PLANNING & SUSTAINABILITY COMMITTEE**9****14 NOVEMBER 2012**

**INVESTIGATION INTO FLOODING ISSUES IN MOOROOBOOL,
WESTCOURT AND BUNGALOW – PEER REVIEW OF THE HYDRAULIC
MODELLING FOR THE MOODY CREEK DRAINAGE STUDY - DIVISIONS 4
AND 5**

Attachment 1 - VDM drawing No. 14 showing the location of Sites 1 and 1A

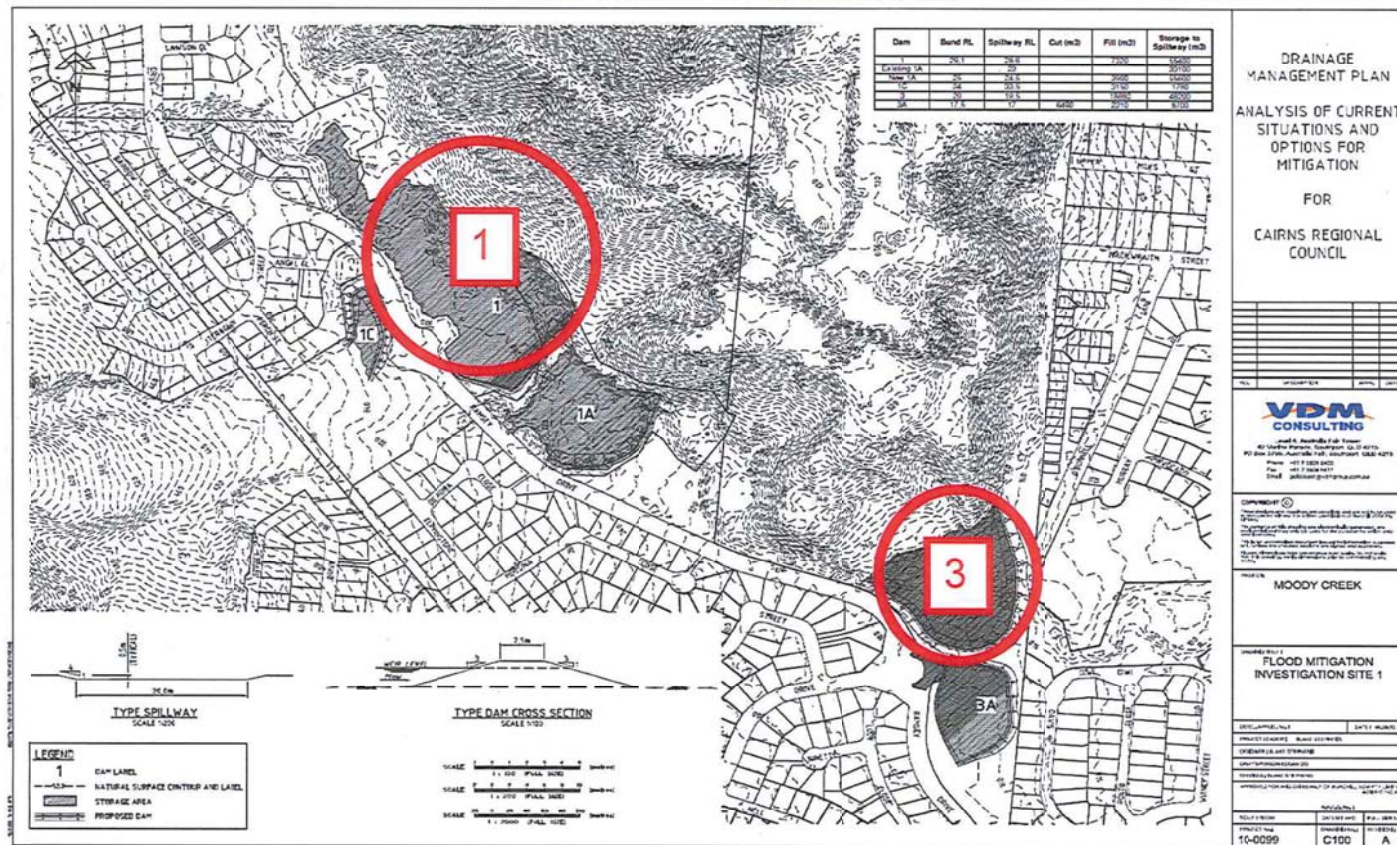
Investigation Site 1&3 — Only site 1 is viable

Attachment 3: Worley Parsons estimated change in flood impacts due to the construction of the new flood detention basin at site 1

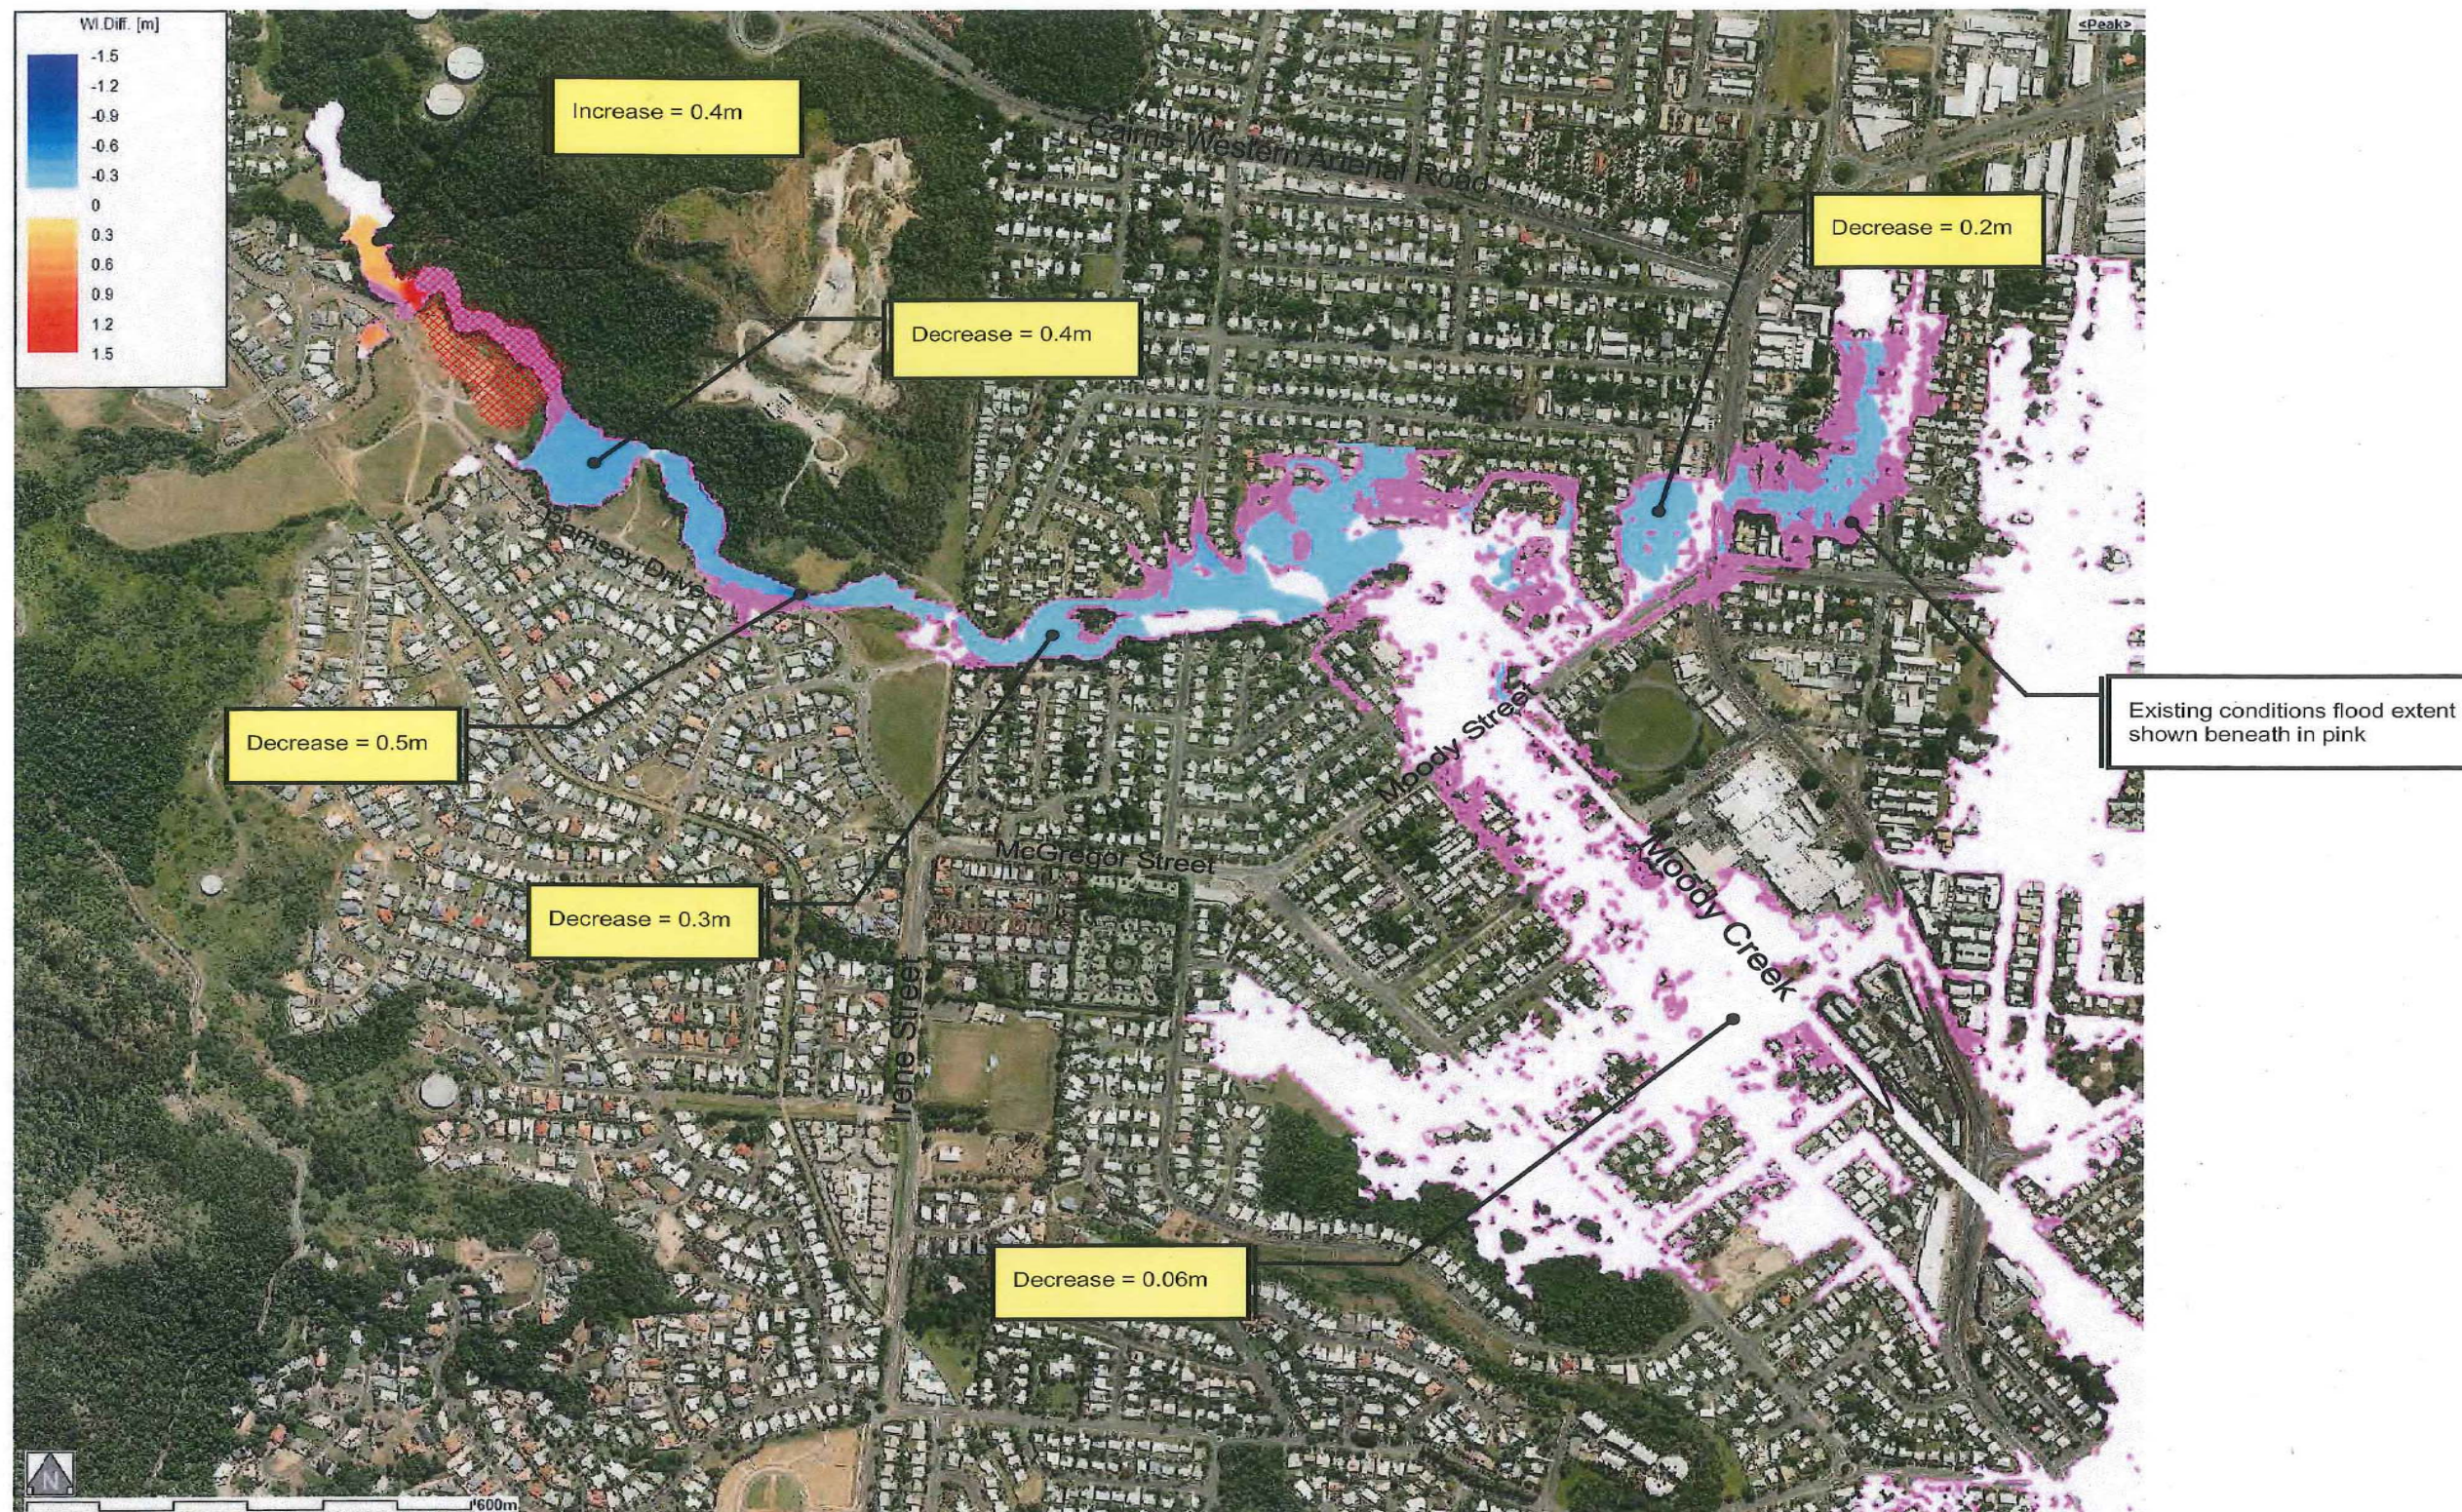
- Worley Parsons pointed out some minor variations in the model outcomes. They suggest flows immediately downstream of Sites 1 and 1A with additional detention would be 30% to 40% less (up to 0,6m depth) with the additional basin and upgrade of the existing basin. Overall they suggest 5% less peak flows in the overall system.

- Refer to attachment 3 for estimated reduction in flood impacts due to the new detention basin at site 1 only, and attachment 4 for the estimated reduction in flood impacts due to the new detention basin plus enlargement of the existing basin.

Attachment 4: Worley Parsons estimated change in flood impacts due to the construction of the new flood detention basin at site 1 plus enlargement of the existing flood detention basin at site 1A

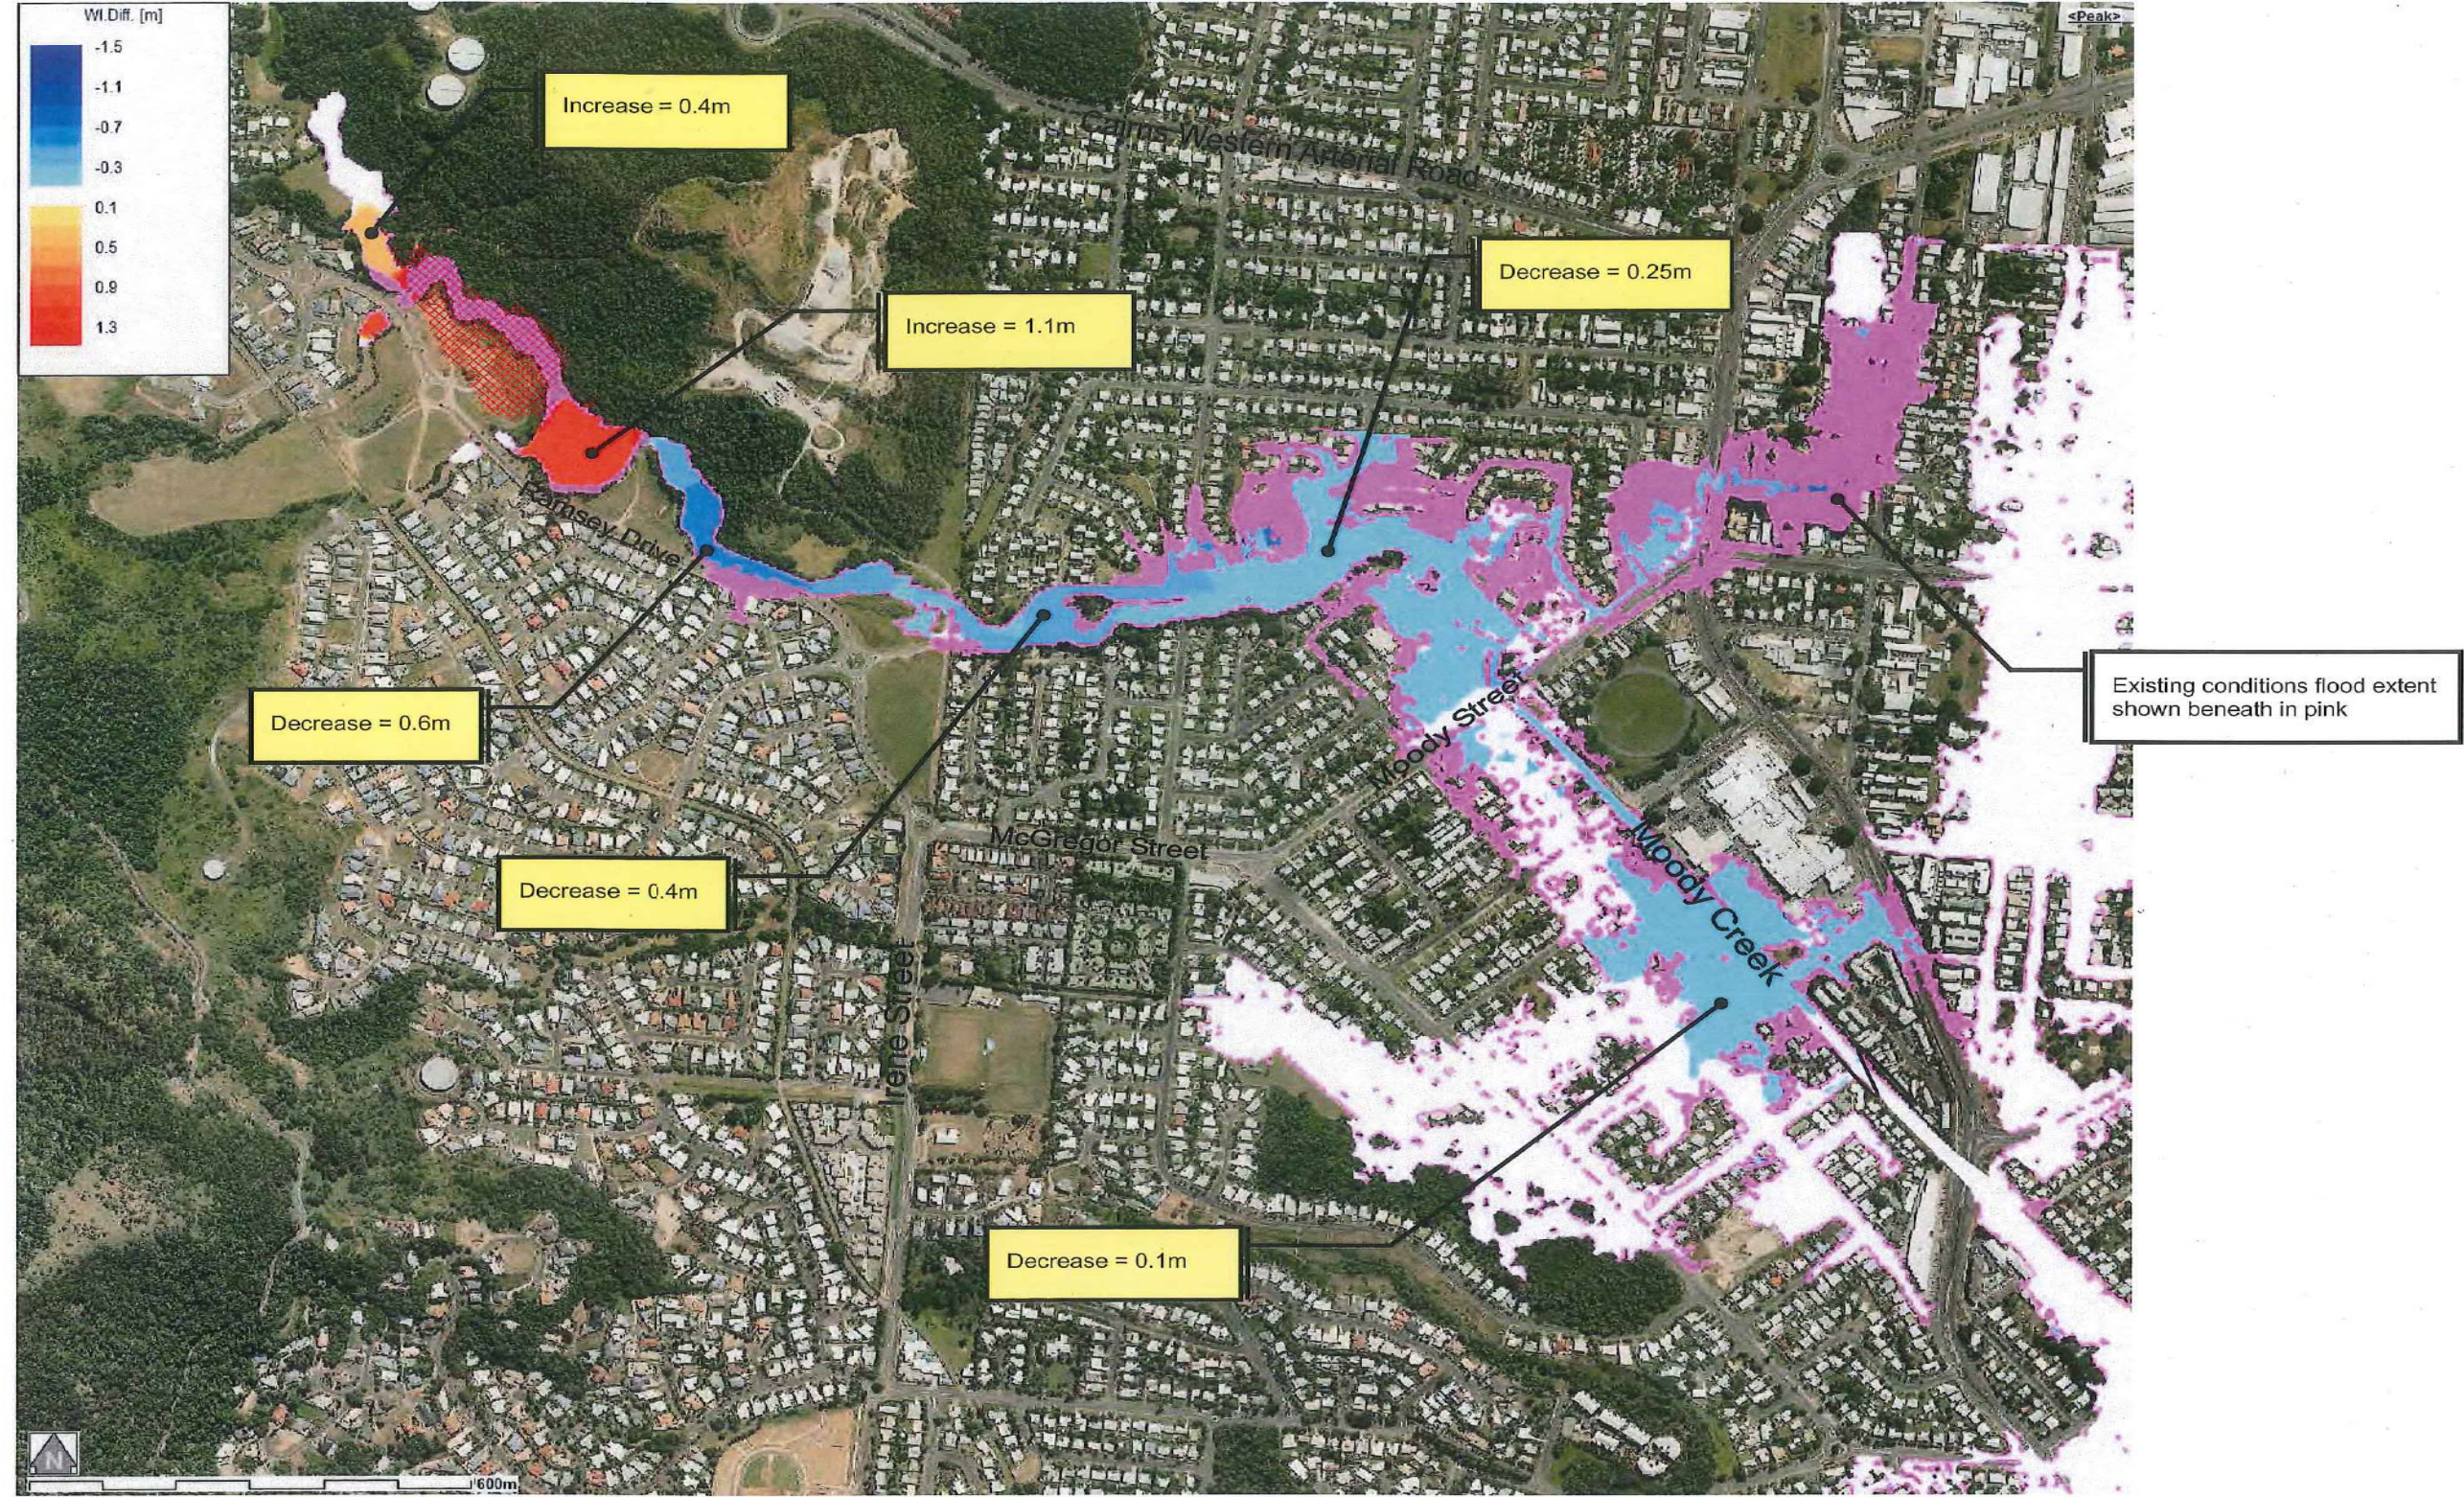
- However, in spite of the lower BCR, Worley Parsons concluded that the overall result still appeared favourable from an economic perspective.
- They suggested that the decision on whether to upgrade the existing detention basin needed to be made on cost. It would deliver benefits to another 24 properties with the 1 in 20 year flood, but at an estimated cost of another \$2M.
